Service Bulletin SB-0013

Subject: MLG wiring harness and brake line rerouting.

Affected Model(s): E1000

Figure 1: Wiring harness and brake line rerouting.

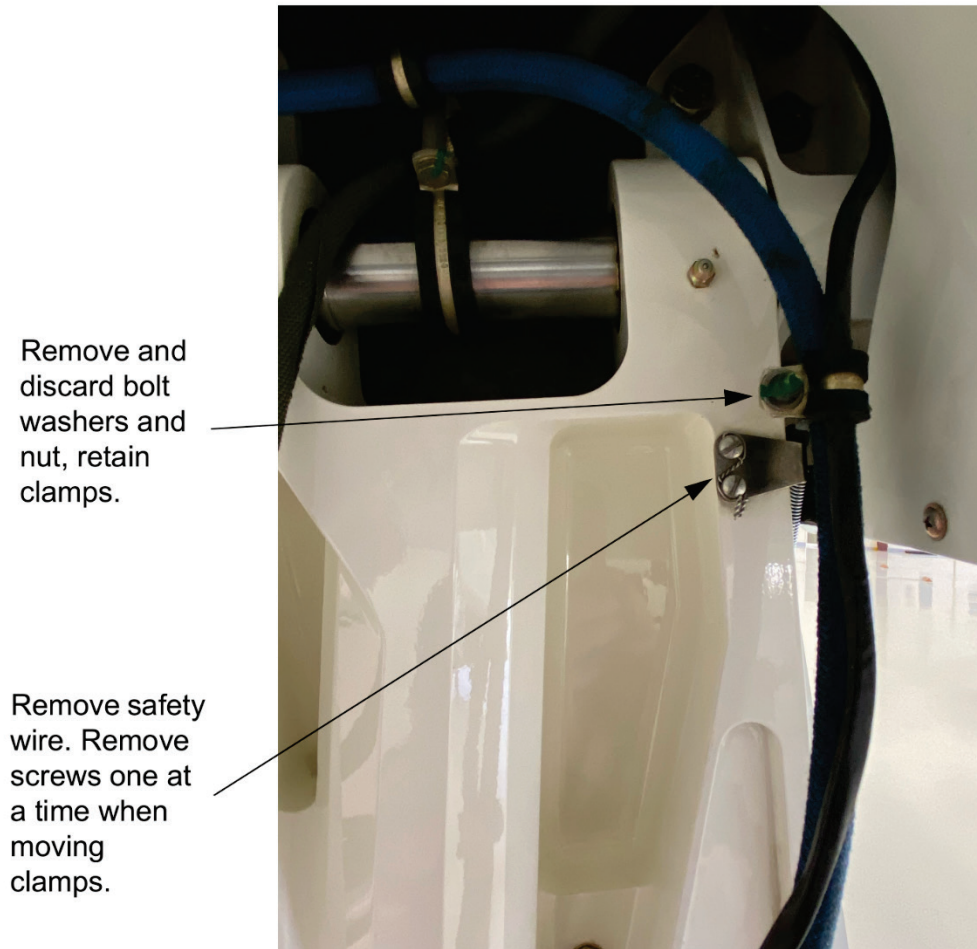
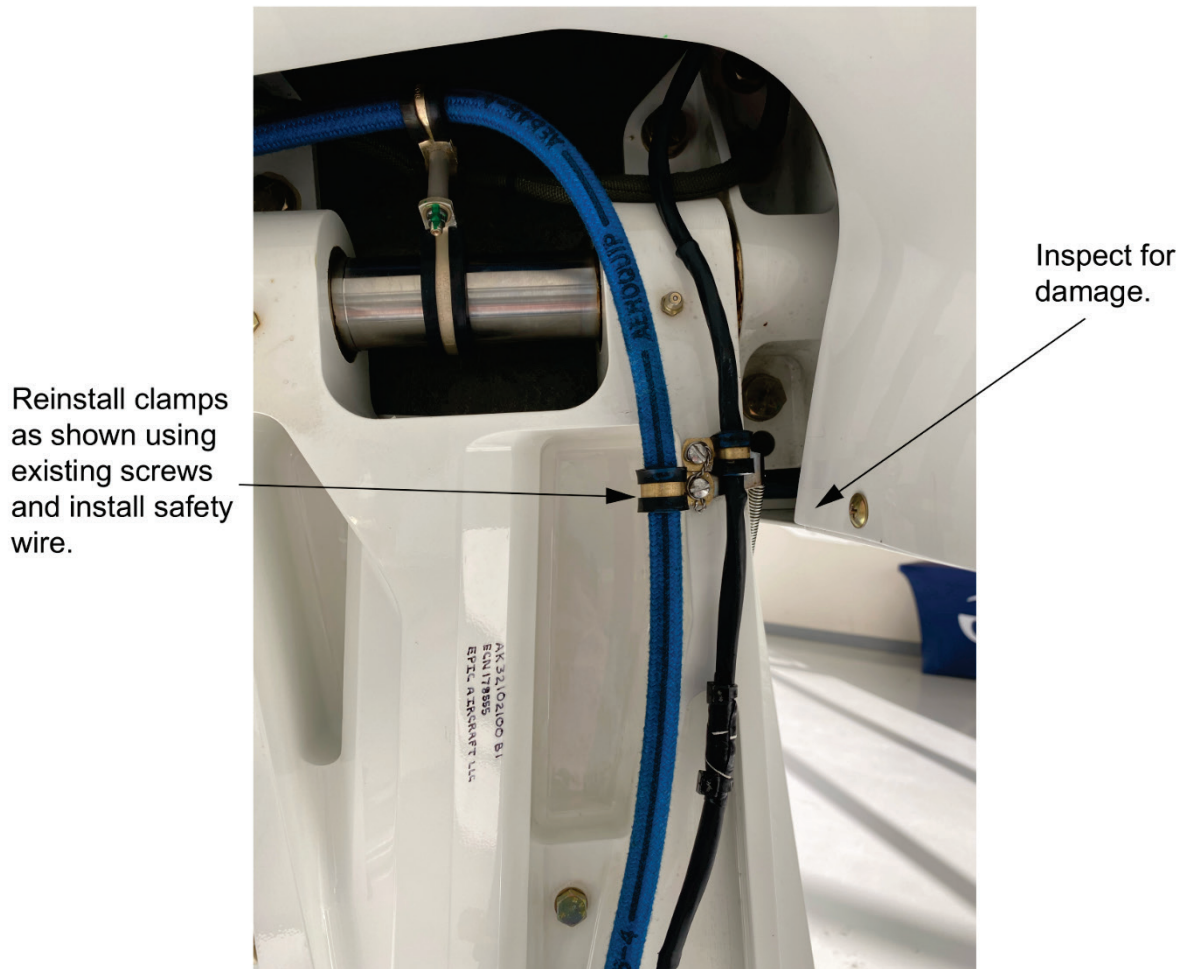
It has been found on affected aircraft that during landing gear extension and retraction, the weight-on-wheels wiring harness can come in contact with the gear well liner.

This Service Bulletin gives instructions to relocate clamps to reroute the wiring harness and brake line on the main landing gear to prevent contact with the wheel well liner.

B) Remove the upper bolt, washers, nut, and clamps that attach the wiring harness and brake line together (refer to figure 1).

F) Install the clamp that attaches the wiring harness to the trunnion with the retained screw (refer to figure 2).

H) Install the clamp that attaches the brake line to the trunnion with the retained screw (refer to figure 2).
